EDWIN I. HATCH NUCLEAR PLANT, UNIT NO. 2

AMENDMENT TO FACILITY OPERATING LICENSE

Amendment No. 21
License No. NPF-5

ATTACHMENT TO LICENSE AMENDMENT NO. 21

FUEL TYPE 8DR 183
MAXIMUM AVERAGE PLANAR LINEAR HEAT
GENERATION RATE (MAPLHGR)
VERSUS AVERAGE PLANAR EXPOSURE
FIGURE 3.2.1-1

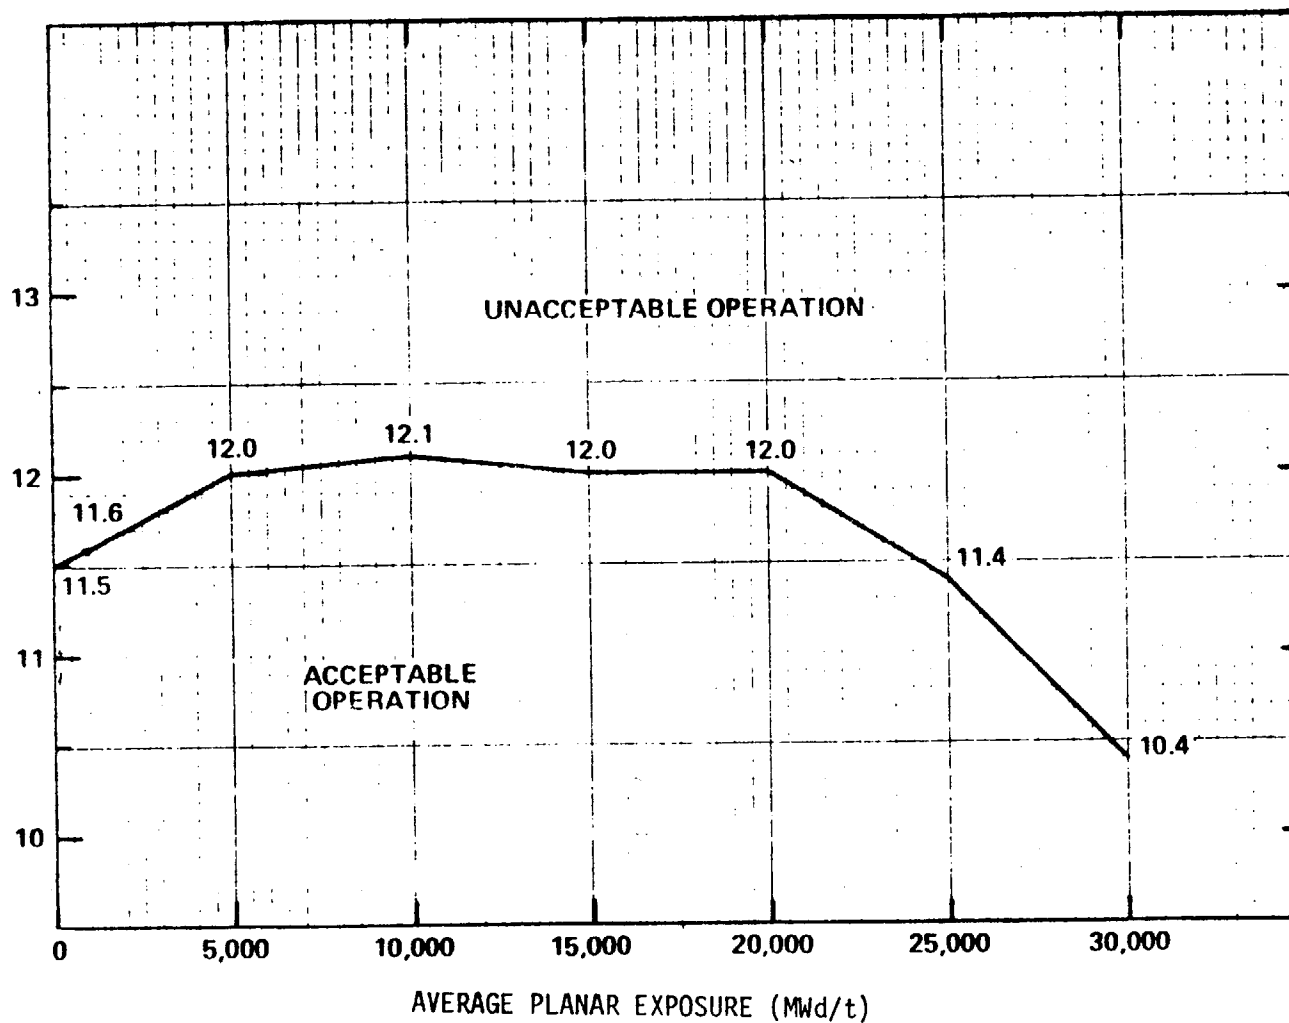
3.2.1 All AVERAGE PLANAR LINEAR HEAT GENERATION RATES (APLHGRs) for each type of fuel as a function of AVERAGE PLANAR EXPOSURE shall not exceed the limits shown in Figures 3.2.1-1, 3.2.1-2, 3.2.1-3, or 3.2.1-4.

With an APLHGR exceeding the limits of Figure 3.2.1-1, 3.2.1-2, 3.2.1-3 or 3.2.1-4, initiate corrective action within 15 minutes and continue corrective action so that APLHGR is within the limit within 2 hours or reduce THERMAL POWER to less than 25% of RATED THERMAL POWER within the next 4 hours.

FIGURE 3.2.3-1

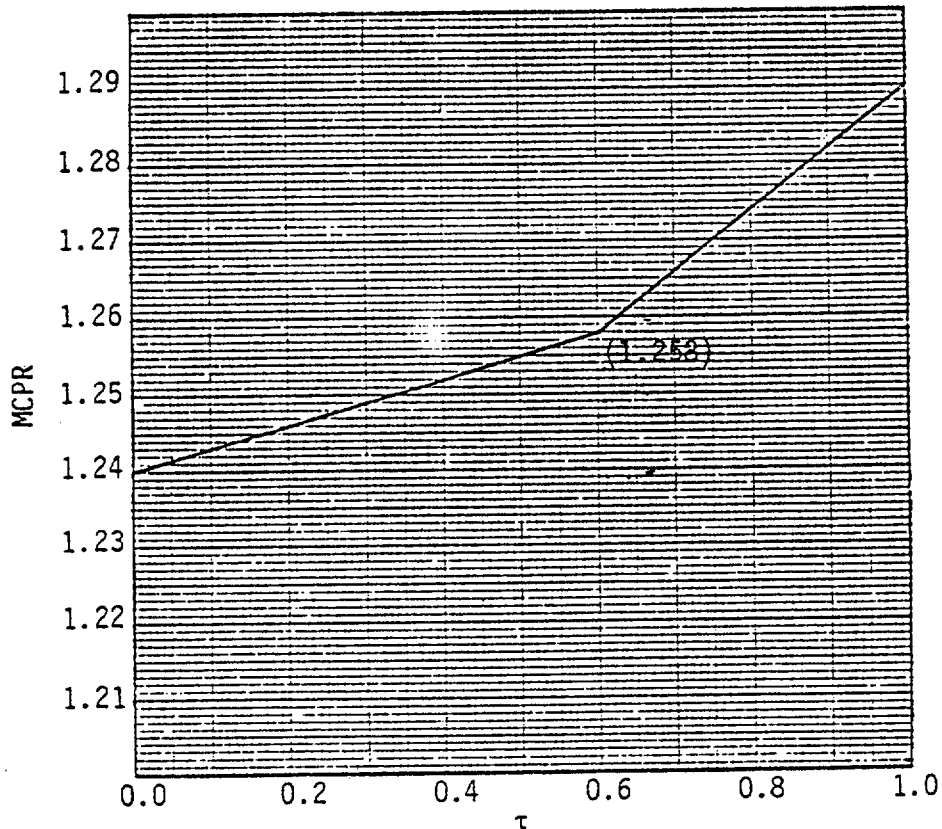
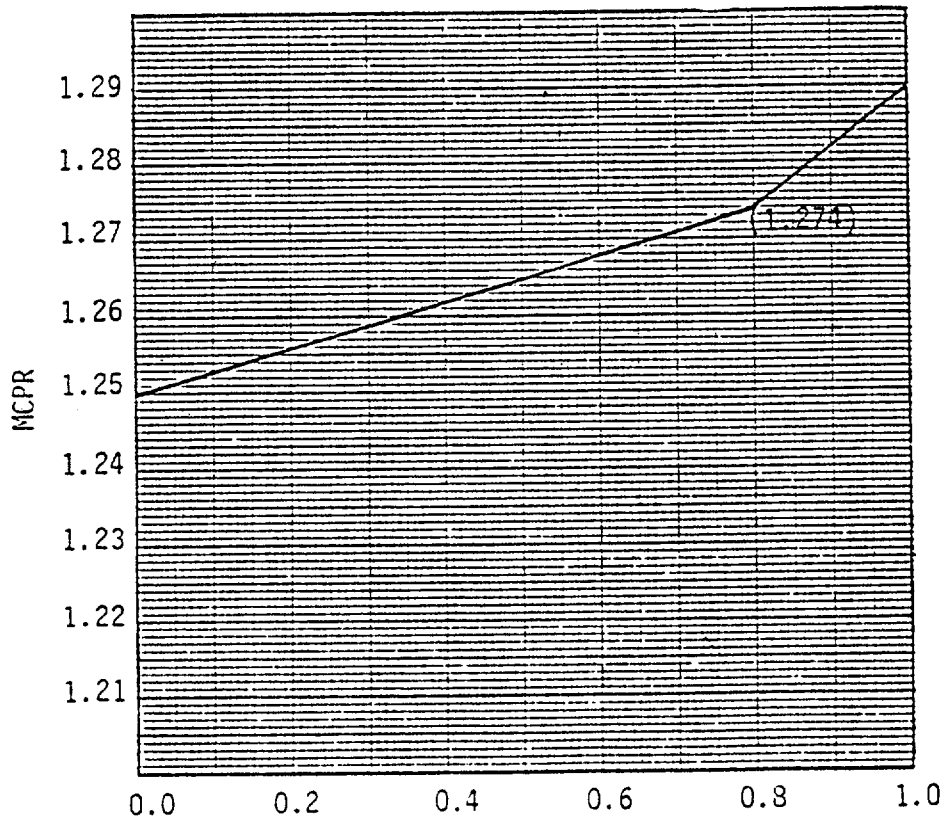
3.2.3 The MINIMUM CRITICAL POWER RATIO (MCPR), as a function of average scram time and core flow, shall be equal to or greater than shown in Figure 3.2.3-1 or Figure 3.2.3-2 multiplied by the K_f shown in Figure 3.2.3-3, where:

4.2.3 The MCPR limit at rated flow shall be determined for each type of fuel (8X8R and P8X8R) from Figures 3.2.3-1 and 3.2.3-2 using:

FIGURE 3.2.3-3

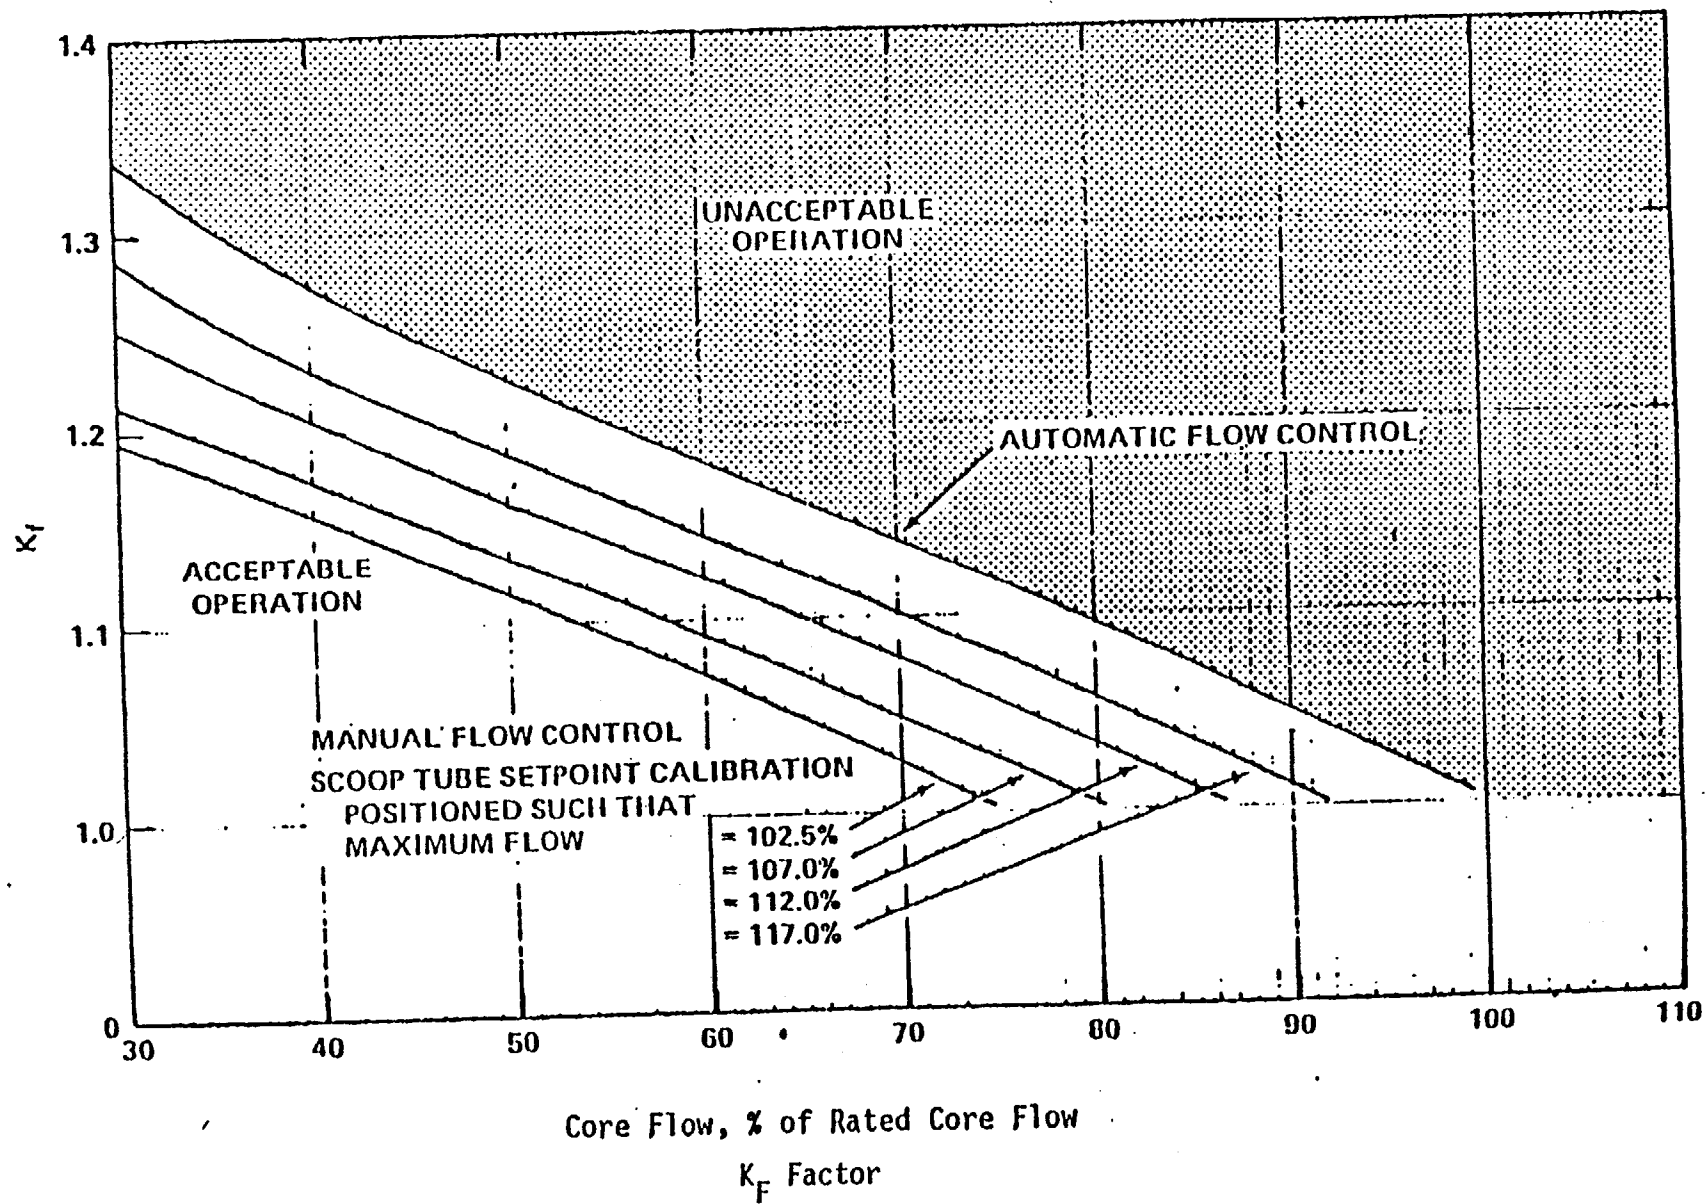
The purpose of the K_f factor is to define operating limits at other than rated flow conditions. At less than 100% of rated flow the required MCPR is the product of the operating limit MCPR and the K_f factor. Specifically, the K_f factor provides the required thermal margin to protect against a flow increase transient. The most limiting transient initiated from less than rated flow conditions is the recirculation pump speed up caused by a motor-generator speed control failure.
